DEVELOPMENT CONTROL COMMITTEE AGENDA

Date: Monday, 26 February 2024

HPBC DEVELOPMENT CONTROL COMMITTEE

UPDATES REPORT

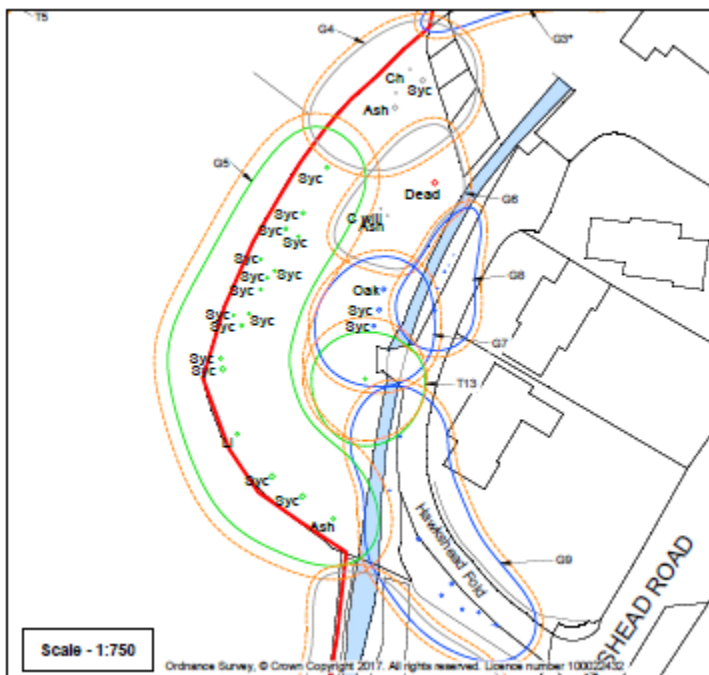
The tree officer has reviewed the updated information and confirms that they have still concerns about the proximity of the development to G4 and G5, two groups of trees on the eastern boundary comprising Sycamore, Ash and Cherry, which includes mature trees (20m+) which are subject to a TPO (see extract from Arboricultural Assessment below).

The layout plan shows a row of terrace properties up against this boundary. The tree officer is concerned that there would be future pressure to remove the trees which would be positioned to rear of gardens due to shading and considers the proposals contrary to policies EQ2 and EQ9 on this basis.
